UNITED STATES PATENT AND TRADEMARK OFFICE

| APPLICATION NO. | FILING DATE | FIRST NAMED INVENTOR | ATTORNEY DOCKET NO. | CONFIRMATION NO. |
|--|-------------|----------------------|---------------------|------------------|
| 10/642,343 | 08/18/2003 | Josef Giessler | 029777-015 | 1920 |

Office Action Summary

DETAILED ACTION

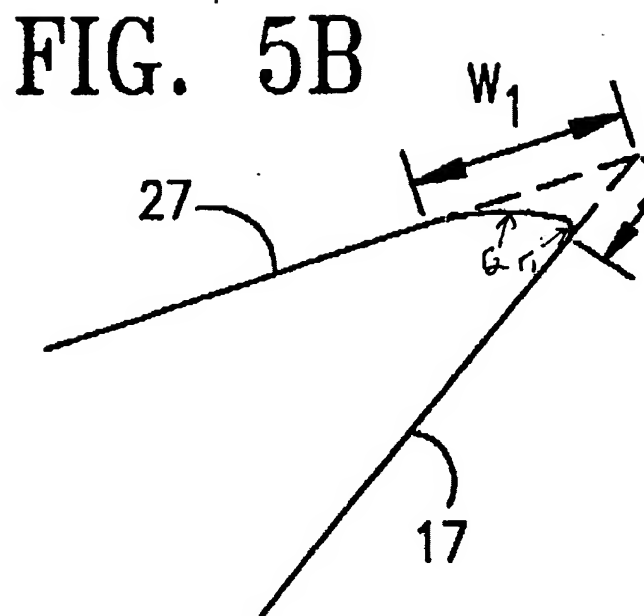
BRITZKE ET AL. teaches a rotary cutting tool (10) comprising a shank (11) and a cutting part (13) disposed at the front end of the shank and defining an axis of rotation (16) and an outer periphery of the cutting part (13) having cutting grooves (15) extending helically to the front end face of the cutting part and each cutting groove disposed rearwardly of the end face defining a helix angle with a plane containing the axis while having cutting edges formed at the edge ('447, Figure 1 and Col. 3, lines 26-38). BRITZKE ET AL. also teaches in figures 5, the helix angle being larger than a cutting-face angle formed between the end face and a front end section of each cutting groove, the cutting-face angle continuously transforming into the helix angle. BRITZKE ET AL. also teaches in figures 5 the cutting-face angle transforming (via a transition) into the helix angle along a constant radius of curvature (figure 5A) as well as the cutting-face angle transforming into the helix angle along a plurality of radii (figure 5B) whereby a first radius adjoins the cutting edge, and a second radius adjoins the helix angle (the first radius being smaller than the second radius: see figure below).
